**SERVICE BULLETIN**

**APPLICABILITY:** 2018MY Crosstrek

**NUMBER:** 12-244-18

**SUBJECT:** Gapping of Rear Quarter Panel Garnish

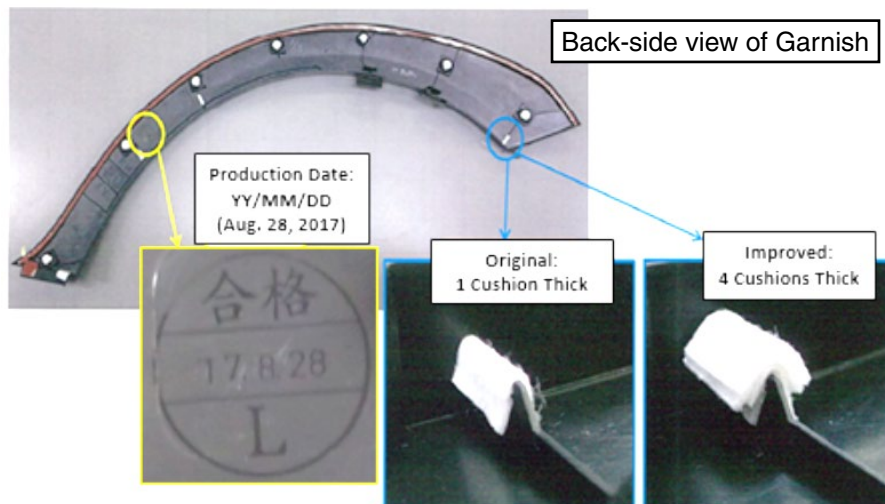
This bulletin outlines changes made to the rear quarter panel wheel arch garnish to eliminate gapping between the inner edge of the trim and the vehicle body as shown in the images below.

To address this condition, changes have been made to the retaining tab at the rear of the garnish. Details of the changes are provided in the Part Information below. The changes were phased into production at two VIN breaks:

- Change #1: **J\*200103**
- Change #2: **J\*225689**

- **Change #1 (Original):** Added 1 thickness of non-woven material to the rear-most retaining tab to enhance garnish retention. These parts were produced between 5/18/2017 and 8/23/2017.
- **Change #2 (Improved):** Stack 4 thicknesses of non-woven material to the tab to further enhance retention and eliminate gapping. The tab was also extended by 1.5mm. These parts were produced on and since 8/24/2017.
